REGULATORY INFORMATION DISTRIBUTION SYSTEM (RIDS)

SUBJECT: Forwards response to EG&G recommendations re technical evaluation rept, "Control of Heavy Loads at Nuclear Power Plants, Diablo Canyon Unit 1 (Phase II)." Revised & addl pages to integrate changes per 830509 submittal also end.

PGandE Letter No.: DCL-84-311

Re: Docket No. 50-275, OL-DPR-76
Diablo Canyon Unit 1
NUREG-0612, "Control of Heavy Loads" - Phase II TER Response

UNIT 1
DIABLO CANYON SITE
FIGURE D-1
CONTAINMENT POLAR CRANE
LOAD BLOCK

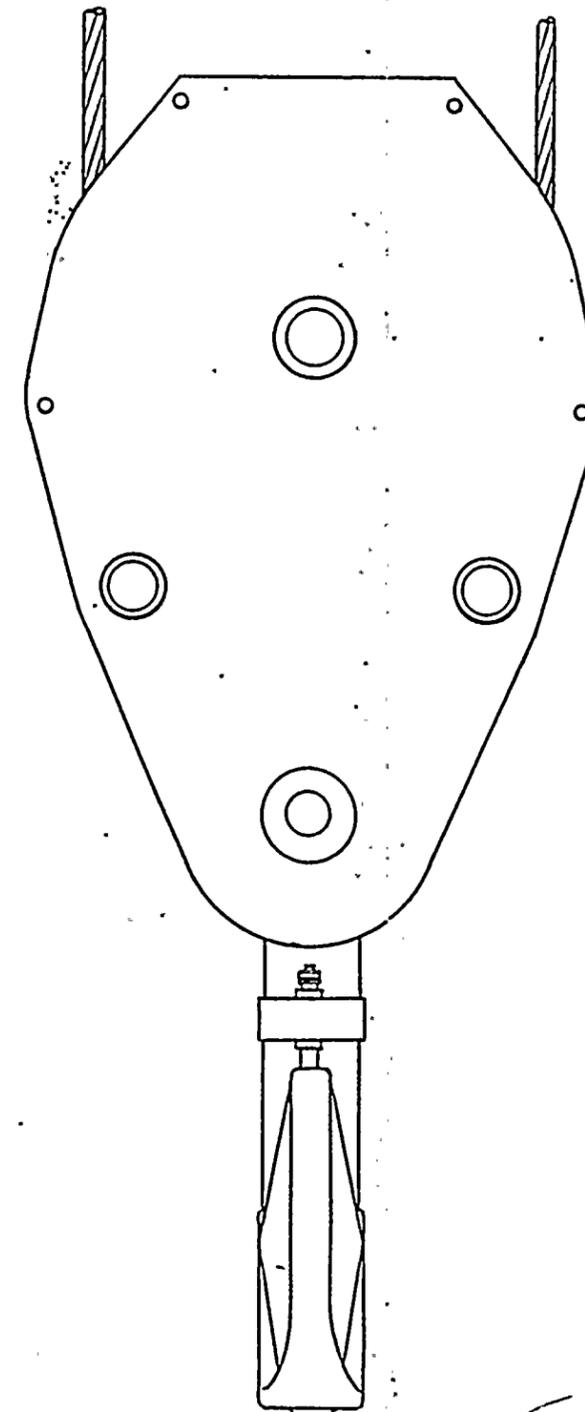
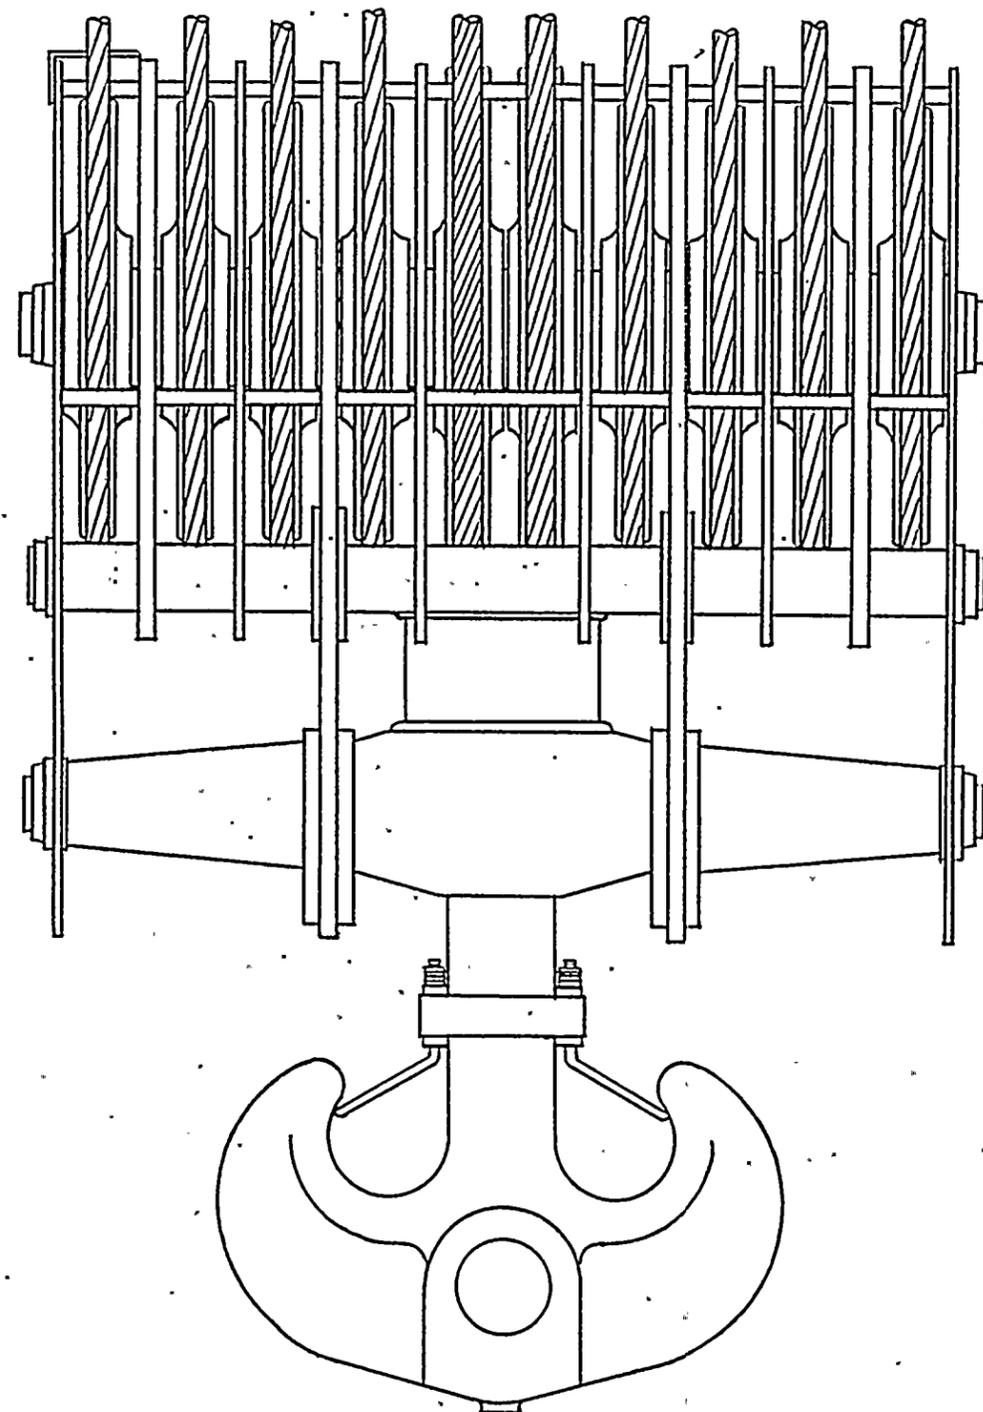
Figure D-1 shows that the load block has no protrusions to catch on a stationary object (such as the crane's gantry leg cross brace), since the hook is protected from above by the sheaves. Since the main hoist load block has no specific load path, its entire travel range was surveyed for protruding stationary objects that could stick through the reeving or catch on the hook. Inspection of the containment between Elevations 140 feet and 202 feet revealed no such object. As for the reactor cavity area, the only overhanging or protruding stationary objects are the reactor missile shield, the reactor cavity service crane, and the manipulator crane. The missile shield is well away from any of the load paths that go over the reactor; it is north, and the load paths are all in the east-west direction. In any case, it has no protrusions in either its operating or stored position (see Figure 2.3.3-1). The two cranes must be stowed away--the reactor cavity service crane latched to the reactor cavity wall, and the manipulator crane moved to the east end of its rails - as a prerequisite to moving any load over the reactor cavity. This prerequisite is in the Maintenance Procedure for every load whose load path is over the reactor cavity, including the load block. The lack of suitable objects for load hangup within the range of the load block, plus the very high safety factors and redundant limit switches, make a load block drop extremely unlikely.
